Access Compliance Report

Public Rights-of-Way

(Curb Ramps)

Intersection ID: 2671	Main Street: ELBERON_CT	Cross Street: MCCHESEY_DR	Location: SW
ADA ID: 2EC16C6F3BC8	Ramp Type: BlendTrans1	Initial Pass/Fail: Fail	Overall Compliance: No
			Severity Score: 21.25

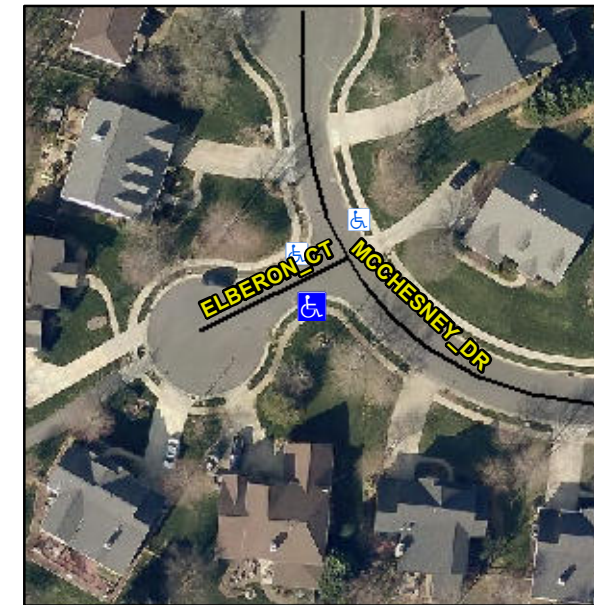
Not Found, R304.5.1, R304.5.3

Remove & Replace Curb Ramp With Two New Directional Ramps or Equivalent.
